**CITY OF CARMEL-BY-THE-SEA  
PLANNING COMMISSION  
SPECIAL MEETING AGENDA**

January 23, 2014  
Thursday  
Tour – 2:30 p.m.  
Meeting – 4:00 p.m.

Planning Commission Report

Planning Commission Report

A-0.1  
SHEET OF

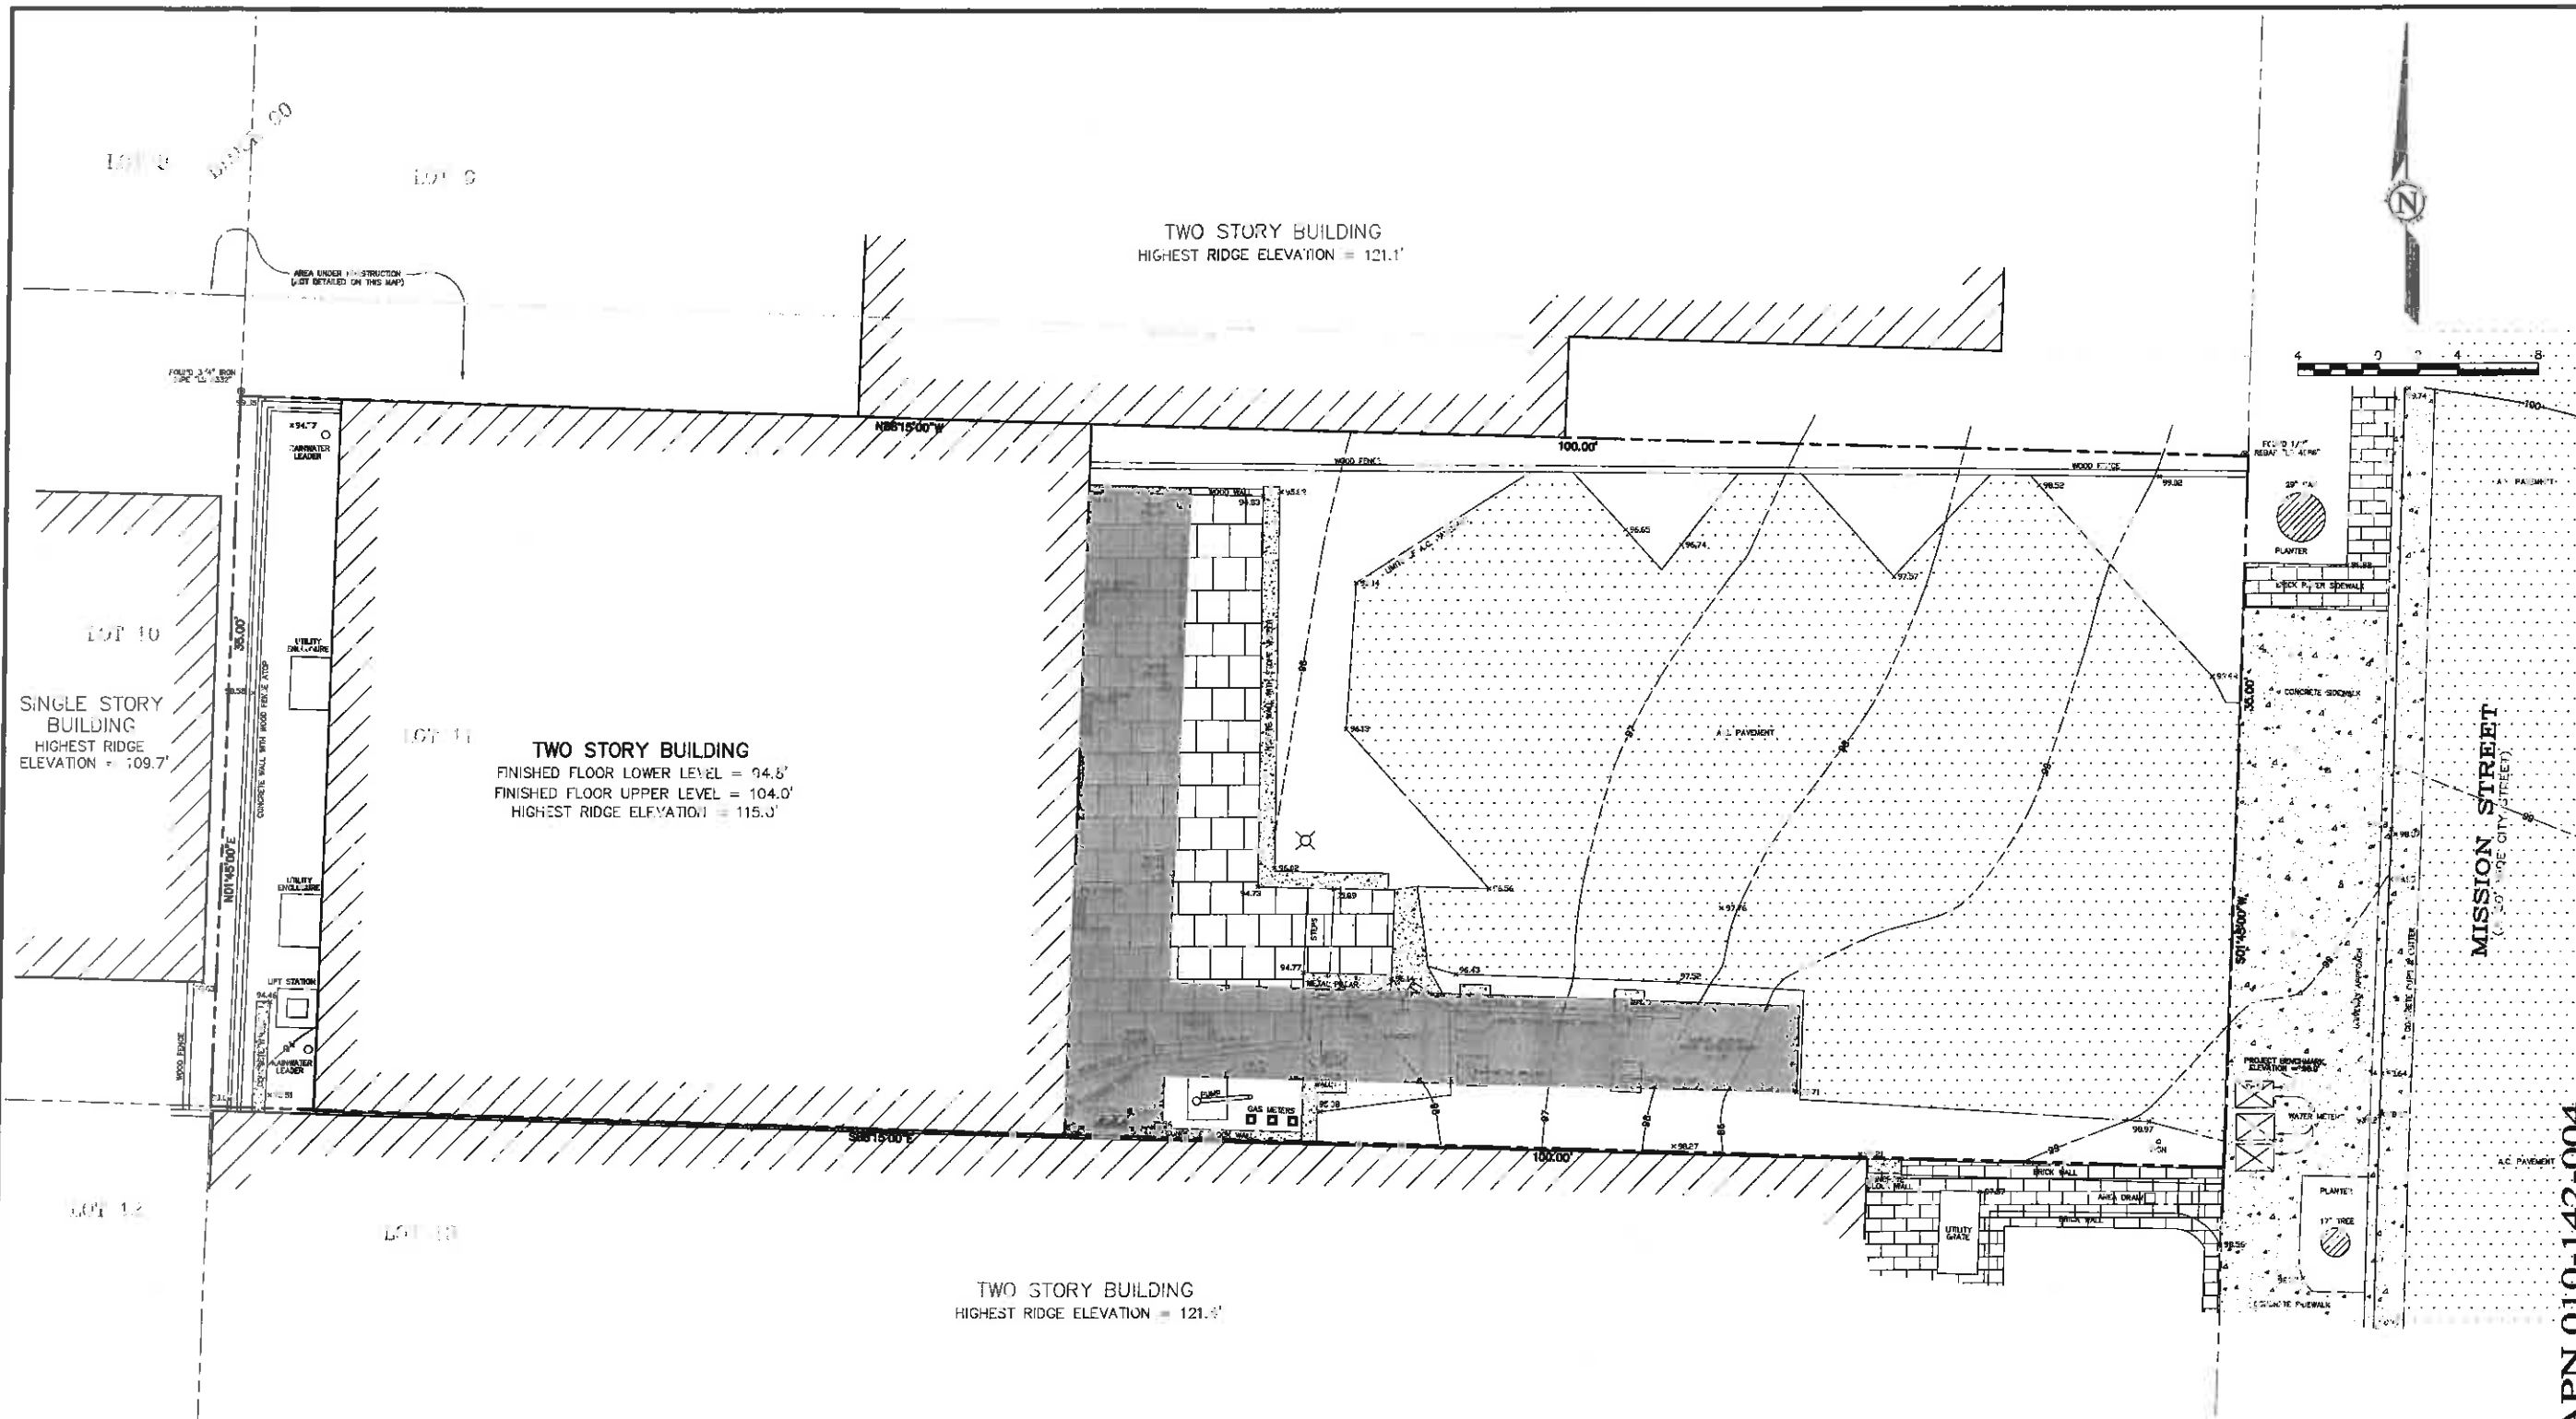
In response to the Planning Commission's recommendation, the applicant is proposing 6-foot high wood gates at the front of the carport. The proposed gates would consist of horizontal wood slats, similar in appearance to the horizontal wood siding used on other portions of the structure. Staff notes that the applicant is also proposing horizontal wood panels on the north and south sides of the carport to screen the parking area. There is a 3-foot gap between the top of the panels and the ceiling of the carport.

RE: Re-submittal - Application Completeness Review  
Use Permit (UP 13-22)  
SS of Ocean Avenue between Monte Verde and Lincoln Streets  
Blk 74; Lot 6 APN: 010-201-005

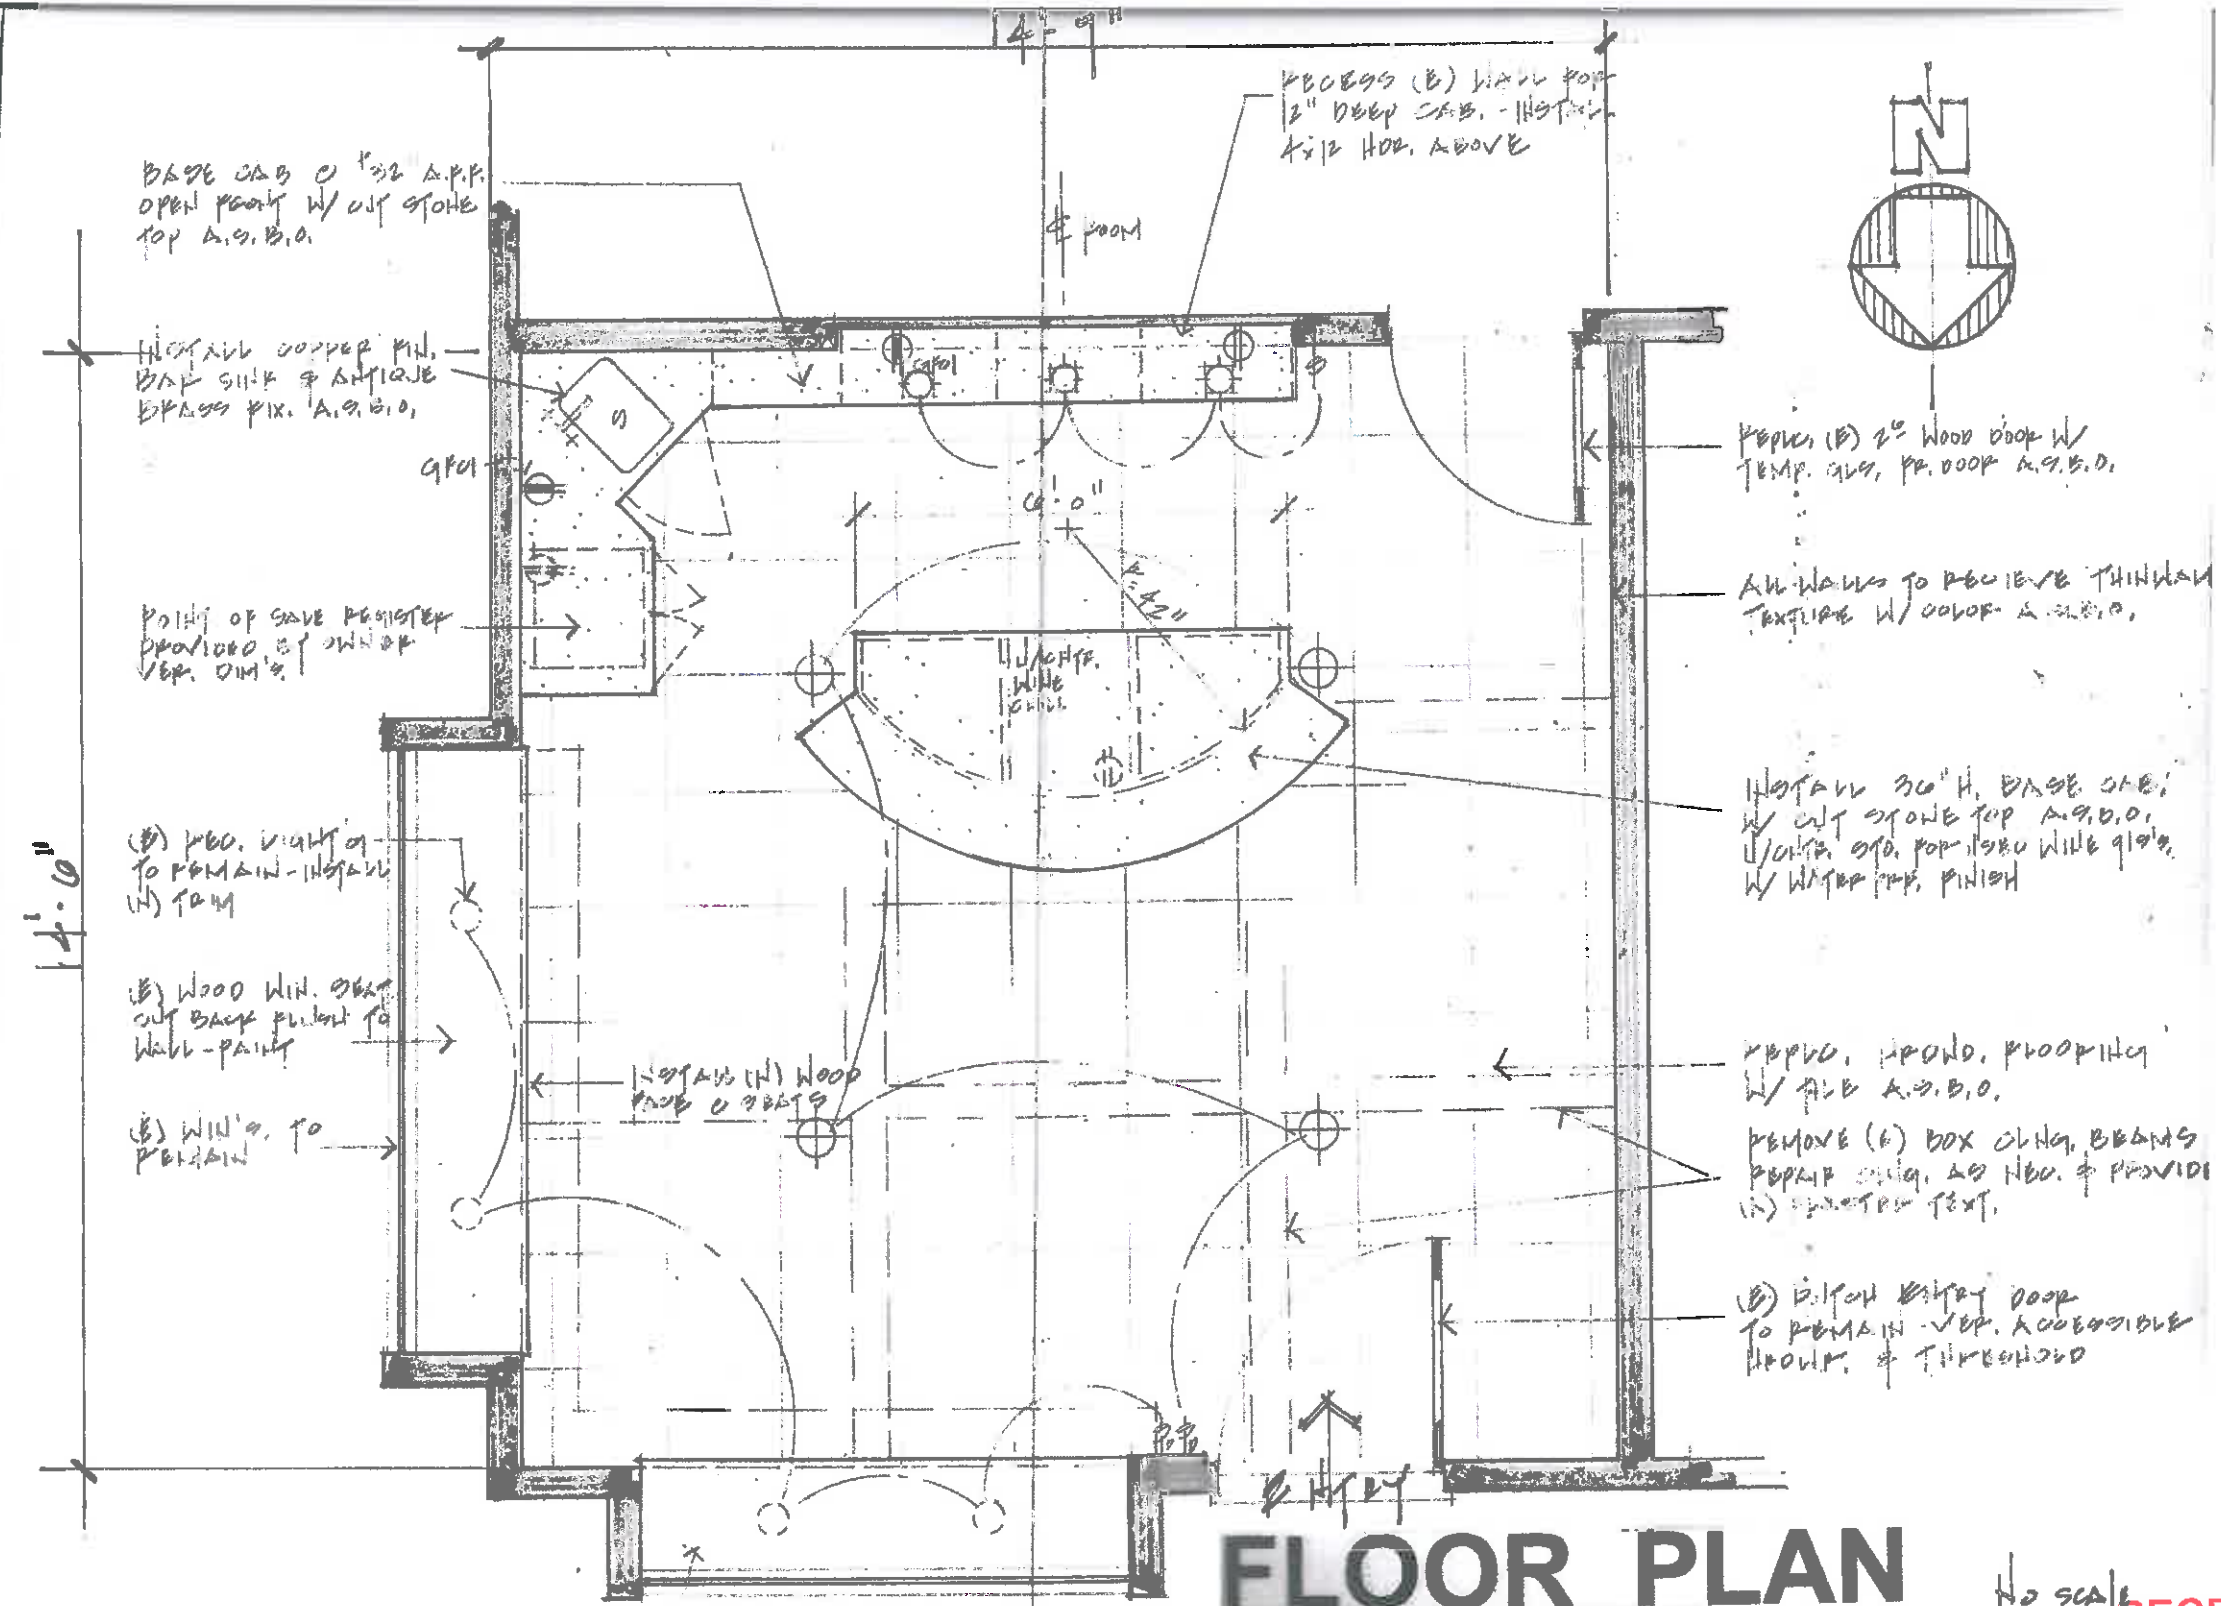
1. Provide a more detailed site plan identifying areas proposed for retail area sales within the space. Clarify if any seating is proposed, and include dimensions of the wine tasting bar.

- Please see updated diagram attached
  - The window seating is currently there, we would like to continue to use it as is. The size of the space will limit the size of our tasting bar to 6-8ft. With the window seating the tasting bar would be standing only for customers. The window seats would be the only seating area. The proposed retail area would consist of a cabinet no larger than 4-5ft x 8ft and will hold hats, tee-shirts, wine logo glasses and corkscrews.
